Subject: Suggestions/Objections to Draft Zonal master Plan of Eco-Sensitive Zone (ESZ) for the Sanjay Gandhi National Park

This is with reference to the public notice dated 09 September 2025 issued by the Municipal Corporation of Greater Mumbai, **inviting objections and suggestions to the Draft Zonal master Plan of Eco-Sensitive Zone (ESZ) for the Sanjay Gandhi National Park.**

Annexure 1: Snapshot of Draft DP 2034 with areas around Vihar lake marked as Natural Areas

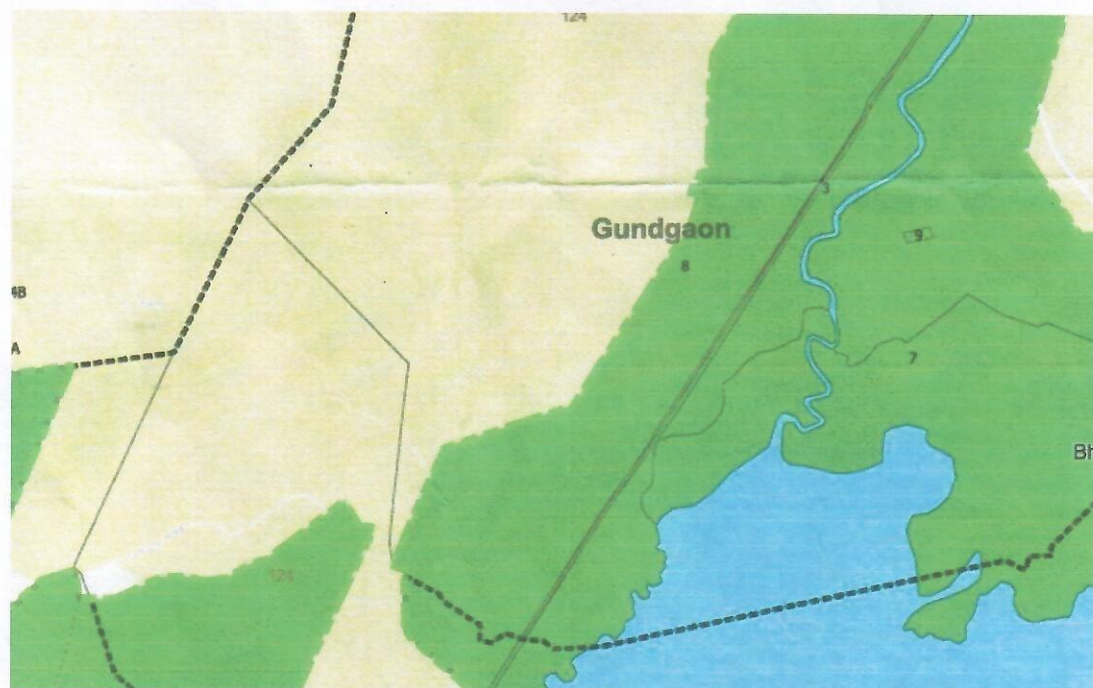
According to the *Development Plan (DP) 2034* and *DCPR Part VII, Clause 3.7*, these areas have been explicitly designated as **Natural Areas (NA) (Annexure 1)**. The permissible activities in such zones are strictly limited to eco-sensitive uses such as boardwalks in mangroves, trekking facilities, public sanitary conveniences for visitors, and sewerage pumping stations.

We strongly recommend that the Natural Areas north of Vihar Lake continue to be protected under the **Natural Area (NA)** land use classification of DP 2034, and that the Draft Zonal Master Plan be revised to designate them as ESZ III - prohibiting all forms of built development in this sensitive zone.

Annexure 3: Water shed Map as seen in the Draft Zonal masterplan for ESZ of SGNP

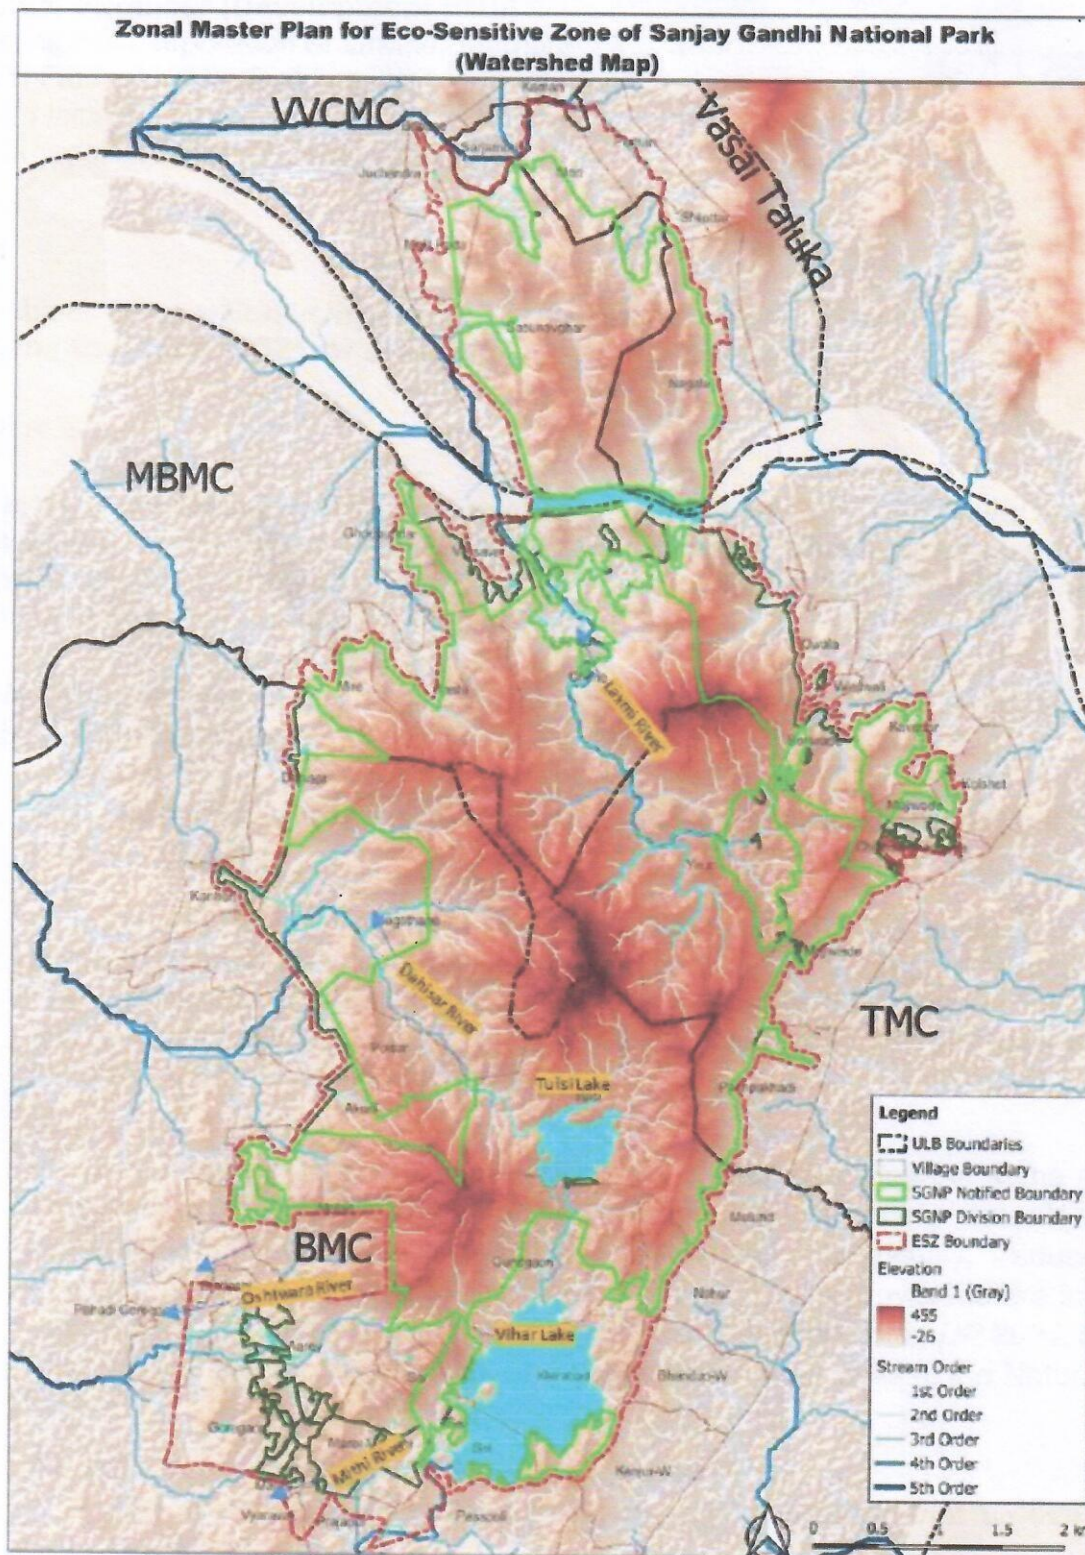
- **A natural drain and catchment area** for Vihar Lake, which plays a vital role in maintaining the ecological and hydrological balance of the region. (Annexure 3)

- **Depletion of biodiversity** and fragmentation of ecologically sensitive habitats.
- **Increased human-wildlife conflicts**, due to disturbance of natural habitats.
- **Disruption of natural drainage and catchment functions** of the Vihar Lake basin, heightening the risk of flooding in adjoining urban areas.
